Serial No. 15-494A  
NLOS/DEA R1  
Docket Nos.: 50-338/339  
License Nos.: NPF-4/7

**VIRGINIA ELECTRIC AND POWER COMPANY (DOMINION)**  
**NORTH ANNA POWER STATION UNITS 1 AND 2**  
**RESPONSE TO NRC AUDIT**  
**REGARDING LICENSE AMENDMENT REQUEST TO ADDRESS THE ISSUES**  
**IDENTIFIED IN WESTINGHOUSE DOCUMENTS NSAL-09-5, REV. 1 AND NSAL-15-1**

**Additional Information in Support of NRC Review of License Amendment Request  
Associated with Westinghouse NSALs-09-5, Rev. 1 and 15-1, Rev. 0**

**Sample Application of an Operating Space Reduction**

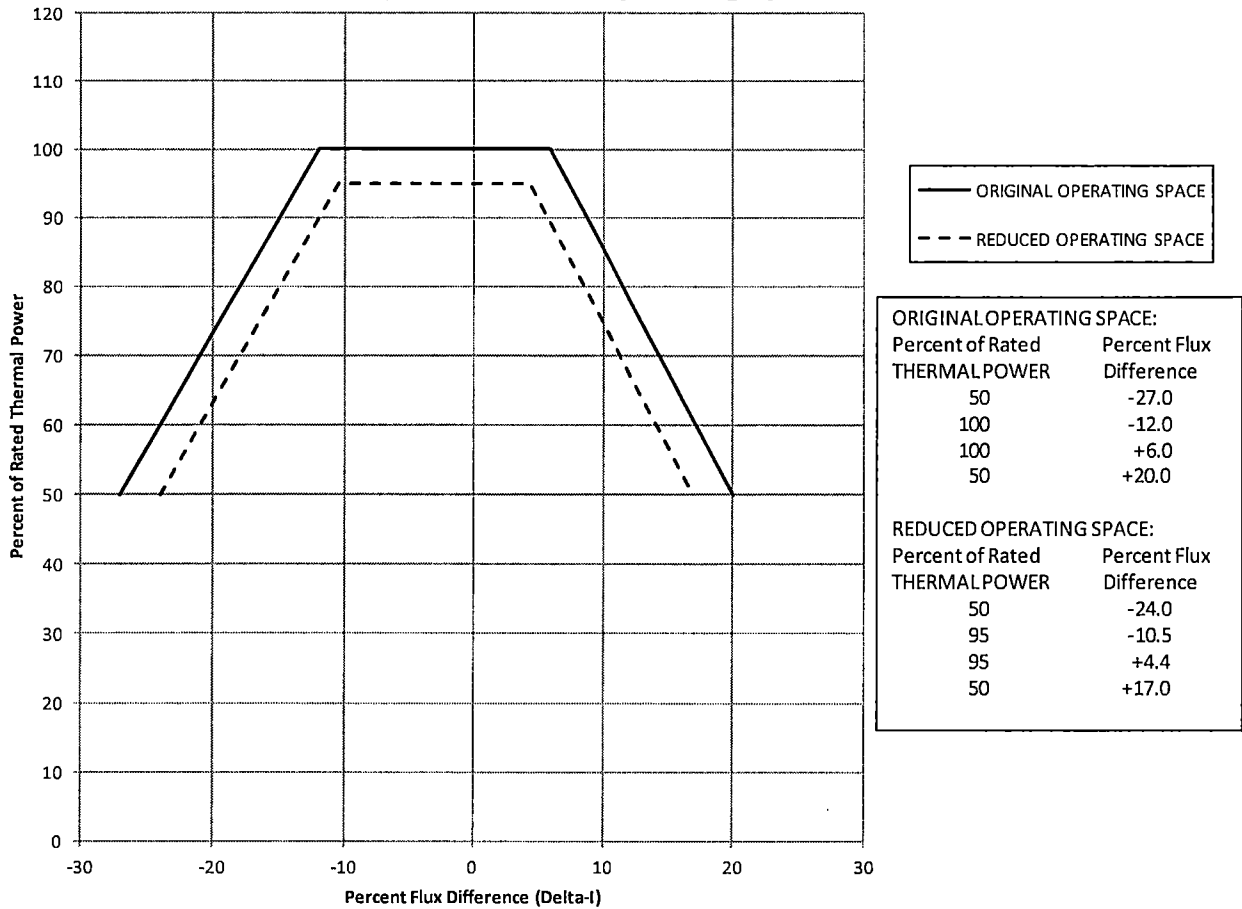
*Regarding LCO 3.2.1, why are the proposed Required Actions B.3 and B.4 indicated to reduce the associated setpoints (Neutron Flux and Overpower delta-T, respectively) for each 1%, 'that THERMAL POWER is limited below RTP by Required Action B.2'?*

During review of this question it was identified that further clarification may be needed regarding AFD limit and THERMAL POWER reductions imposed by Required Actions 3.2.1.B.1 and 3.2.1.B.2, respectively. The AFD band and THERMAL POWER reductions are designed to limit the operating space in which the unit can operate to maintain margin for  $F_Q^T(Z)$ . Application of the power reduction is meant to limit the maximum THERMAL POWER at which the unit can operate (less than RTP). Likewise, application of the AFD limit reductions are meant to narrow the AFD limits from what is specified in the COLR. Therefore, a modified version of the proposed COLR Table 3.2-3 (Attachment 1 of Reference 1) is provided to more clearly define the Required Actions. An example application of the operating space reductions is presented after proposed COLR Table 3.2-3.

- 1) The results of a flux map analysis show that  $F_Q^T(Z)$  exceeds the limit by 1.5%.
- 2) THERMAL POWER is limited to ≤ 95% RTP. If current THERMAL POWER > 95%, reduce power to ≤ 95% RTP.
- 3) Negative and Positive AFD bands from COLR Figure 3.2-2 are narrowed by ≥ 3.0%. Adjust AFD as necessary to adhere to the limitation in Table 3.2-3.
- 4) The figure below illustrates: a) the original operating space and b) the reduced operating space needed to improve margin for  $F_Q^T(Z)$ .
